Agenda
Hearing Examiner Meeting
Thursday, October 20, 2022
Richland City Hall ~ Council Chamber
625 Swift Boulevard
[Zoom](#) ~ Public Telephone Access: (206) 337-9723 or (253) 215-8782
Meeting ID No. 872 2126 7401

1. S2022-104 Wellhouse Heights II
2. SPR2022-101 Jadwin McMurray Apartments

S2022-104 Wellhouse Heights II

Landscape Plan

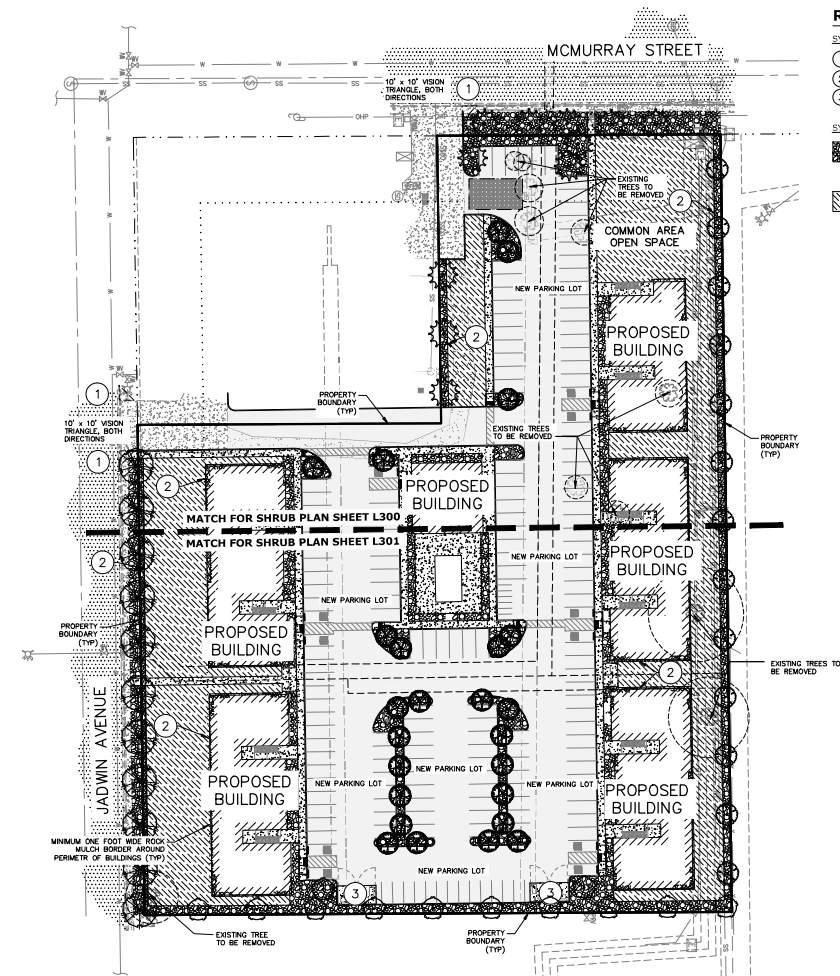
14. All pedestrian ramps, driveway entrances and sidewalks shall be designed to current City standard details and A.D.A. standards.
15. The vision-clearance triangle needs to be shown on the construction plans, in accordance with RMC Chapter 12.11.020. The landscaping plan provided (Sheet L100) shows trees/landscaping within right-of-way and in the vision-clearance triangle, this is not allowed. Trees shall be kept on the property, and not planted in the ROW. The "vision triangles" depicted on sheet L100 are inadequate.
